LANDMARK COMMISSION**July 6, 2026**

FILE NUMBER: COA-26-000180
LOCATION: 5616 Columbia Ave
STRUCTURE: Contributing
COUNCIL DISTRICT: 14

A Certificate of Appropriateness to rebuild and reconfigure the existing (non-original) side addition.

PROPOSED - FRONT ELEVATION
 SCALE: 1/4" = 1'-0"

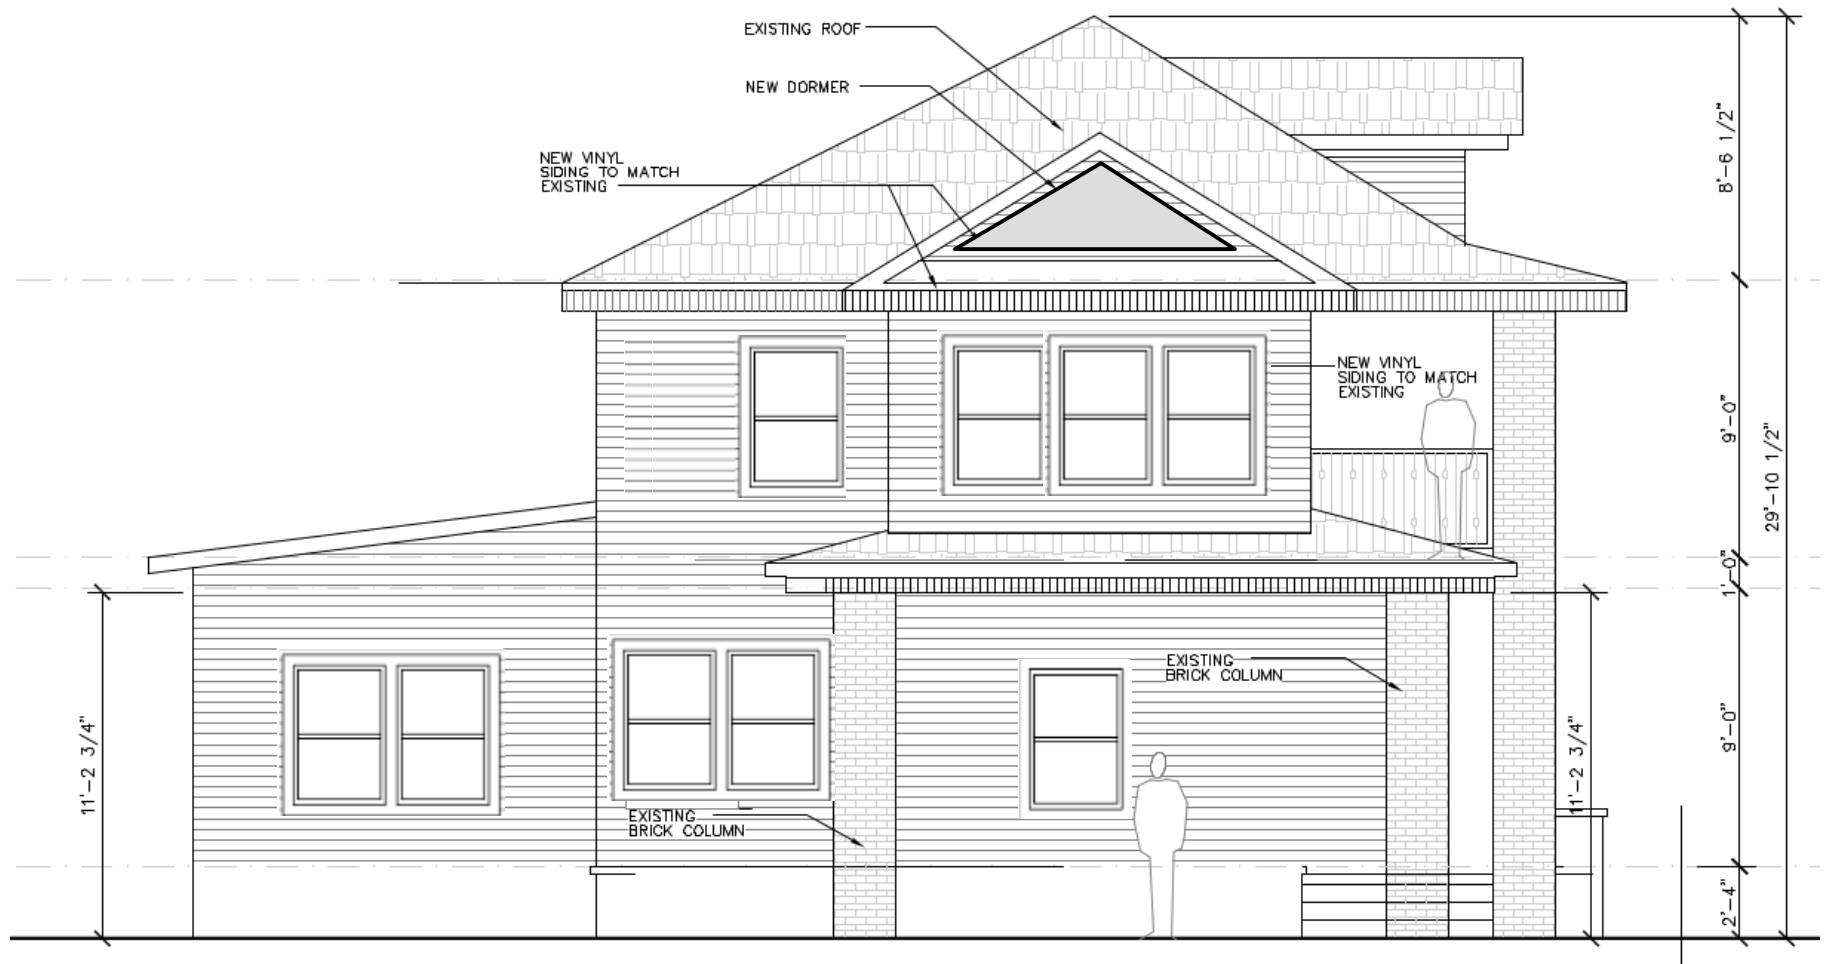
That the Certificate of Appropriateness to rebuild and reconfigure the existing side addition roof be approved with the conditions that drawings and specifications indicate a distractive hipped or gable roof on the dormer/side addition and that detailing matches the existing main structure. Recommend that the side elevation with the dormer show more information, that the hipped roof is more appropriate, and that the roof specification sheet and side elevation roof specifications match.

That the Certificate of Appropriateness to rebuild and reconfigure the existing (non-original) side addition be approved with the following conditions: 1. That the roof on side addition be hipped with a 6:12 pitch, 2. that all replacement siding be #117 novelty wood siding to match original, and 3. that all fenestration remain and not be removed. Implementation of the proposed conditions would allow work to be consistent with preservation criteria Section 8; City Code Section 4.501(g)(6)(C)(i) for contributing properties, and the Secretary of the Interior's Standards for Rehabilitation.

PROPOSED - SIDE ELEVATION
SCALE: 1/4" = 1'-0"

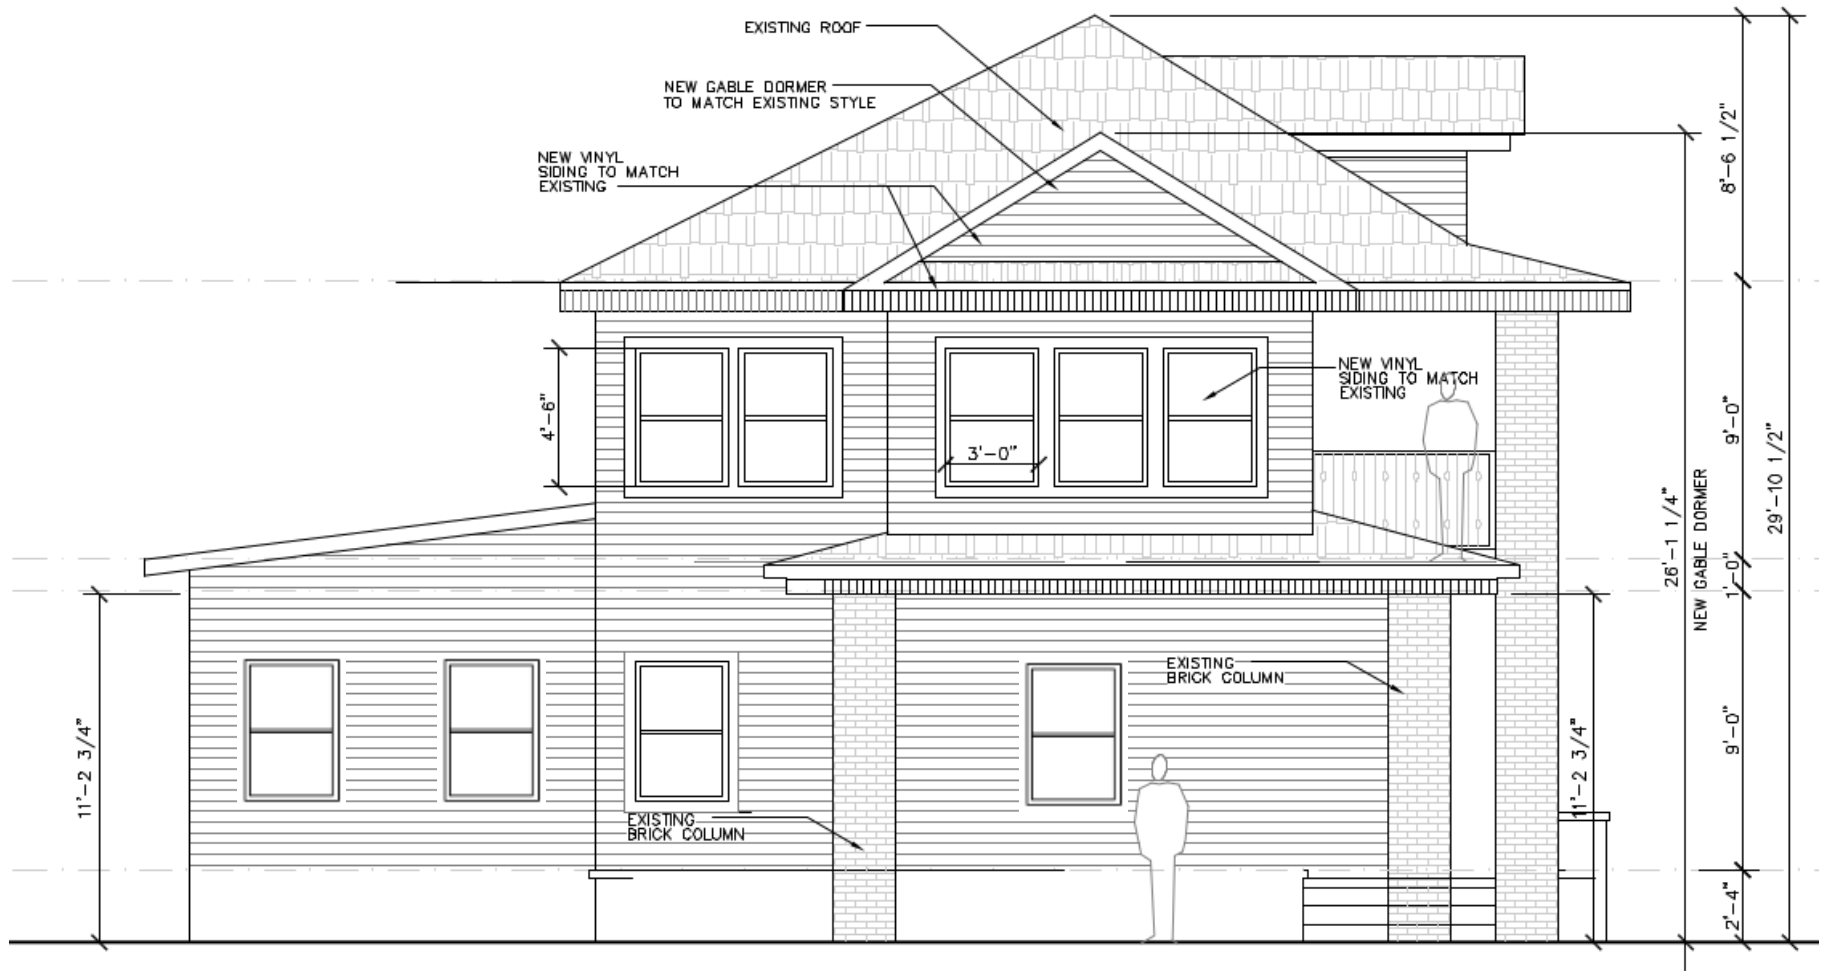
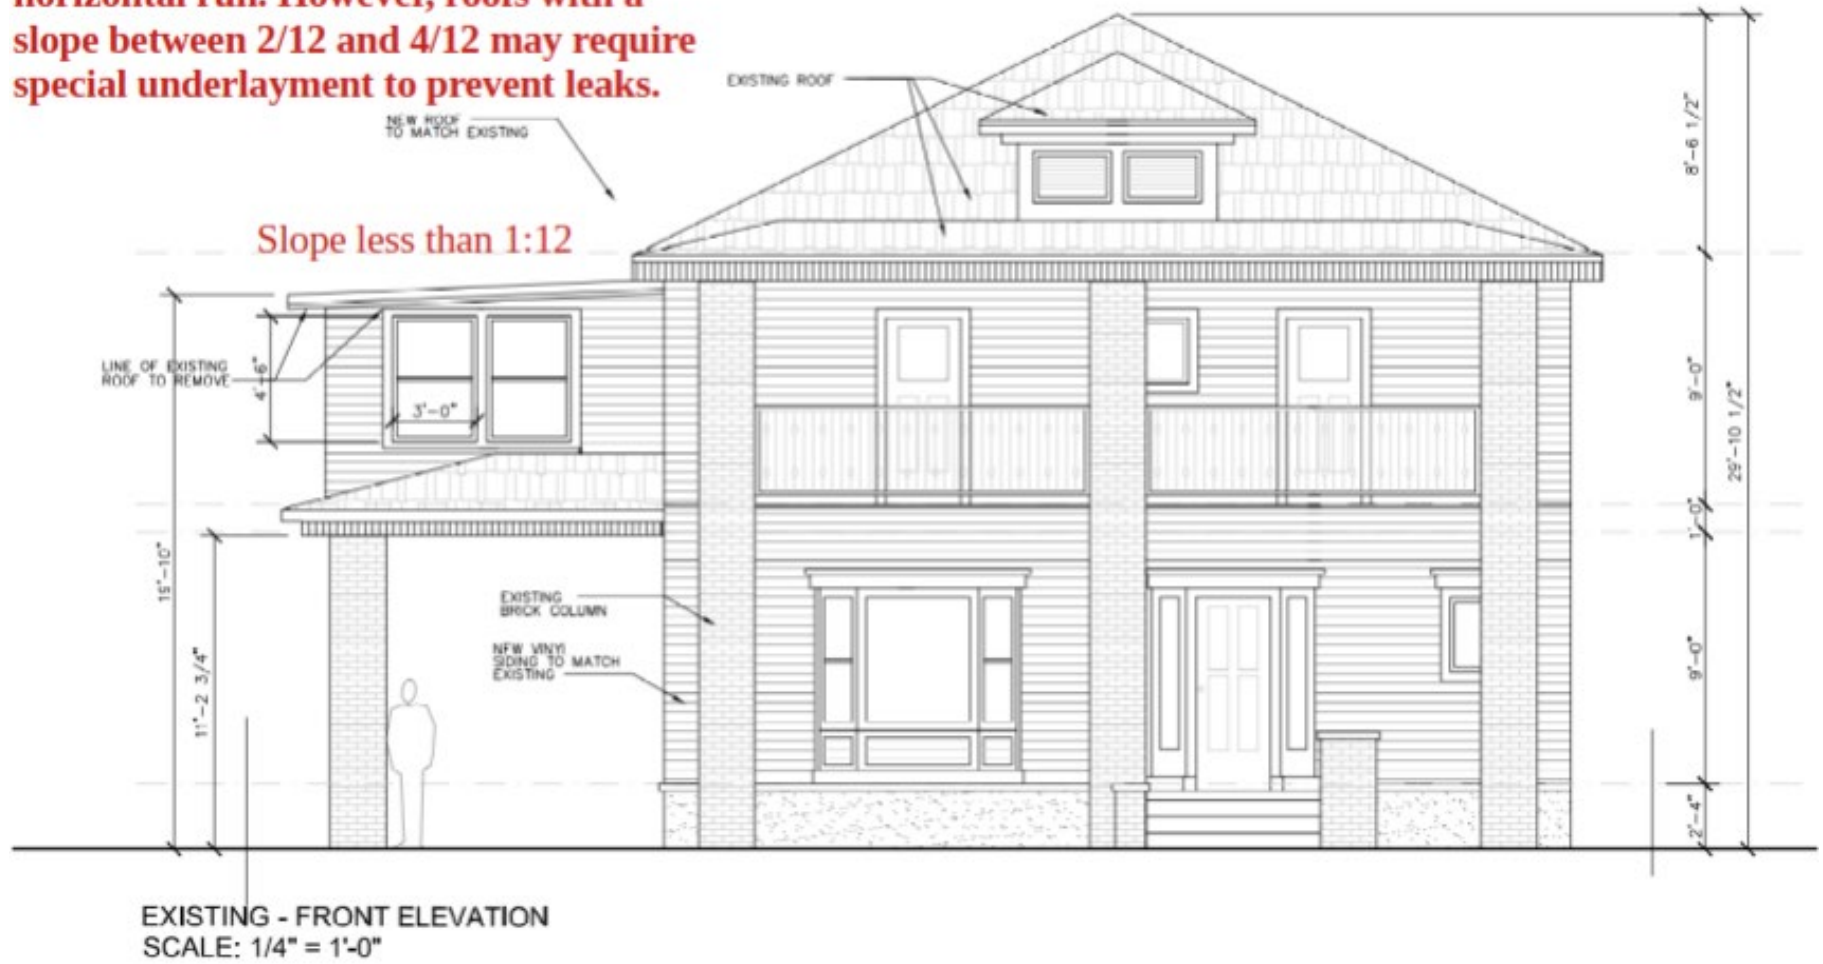
drawings show whether hipped or gable roof on dormer and detailing match rest of house

Rec: Side elevation w/ dormer (more information), hipped roof more appropriate, Roof & elevation roofs must match.
